SERVICE ADVISORY # 15-227

Summerland Mini Fuse

Model and Serial Numbers Included: 2015 Summerland Mini 1400FD, 1600BH, 1700FQ, 1800BH

Fig. 1

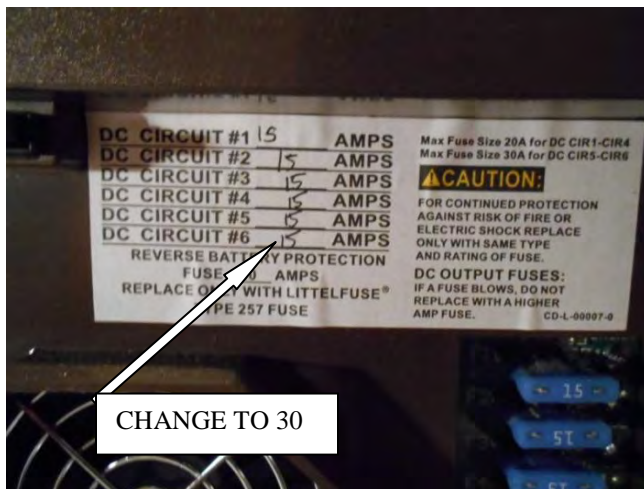
It has been determined the below listed vehicles were manufactured with an undersized 15 amp fuse placed in the battery charging circuit which should have a 30 amp fuse. The circuit is wired and rated for 30 amp capacity. This advisory explains how to correct.

Step 2 Locate the fuse panel in the unit. Remove the 15 amp fuse from the number 6 location of the fuse panel. Replace the fuse with a 30 amp fuse. Change the noted fuse size of position 6 on the information label from 15 to 30.
